INDESIT company

Model type:
WI42EX

Commercial code:
F030499

Notices

n1040376: Drain pump with filter with pin.

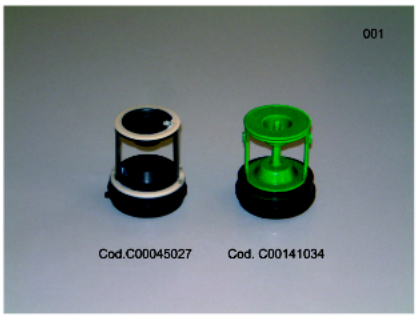
A new drain pump with filter with pin has been introduced progressively as from serial no. 50609.0001.

New parts:
C00119307 - Drain pump with pin filter;
C00141034 - Askoll / Plaset drain pump with pin filter kit (figure 001);

Premodification parts:
C00092264 - Drain pump;
C00045027 - Askoll / Plaset pump filter kit (figure 001);

The new parts can be used on all WASHING MACHINES previously equipped with the premodification parts.
